**DOCKET NO. 50-255, LICENSE DPR-20, PALISADES PLANT**  
**CORE OPERATING LIMITS REPORT – REVISION 10**

Revision 10 of the Palisades Core Operating Limits Report (COLR) is attached. This revision contains the following changes:

**PALISADES CORE OPERATING LIMITS REPORT  
Revision 10**

**Figure 2.2-1 Regulating Rod Group Position Limits**

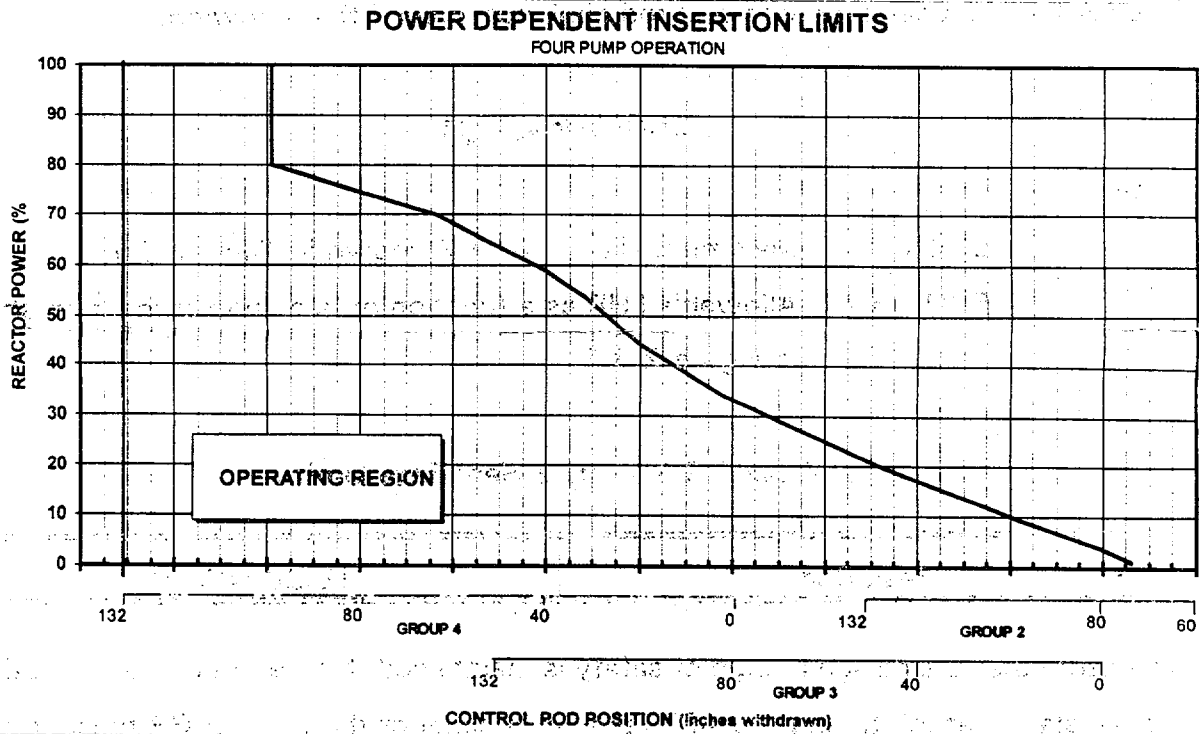
An administrative change to Section 2.2, "Regulating Rod Group Position Limits," which clarifies and more logically organizes the section's content;

- a. If the reactor is critical, to implement the limits on SHUTDOWN MARGIN, individual rod worth and hot channel factors, the limits on control rod regulating group insertion shall be established as shown on Figure 2.2-1.
- b. If the reactor is subcritical, the rod position at which criticality could be achieved if the control rods were withdrawn in normal sequence shall not be lower than Group 2 at 72 inches (ie, ~ 45% control rod insertion)
- c. The sequence of withdrawal of the regulating groups shall be 1, 2, 3, 4.
- d. An overlap of control banks in excess of 40% shall not be permitted.
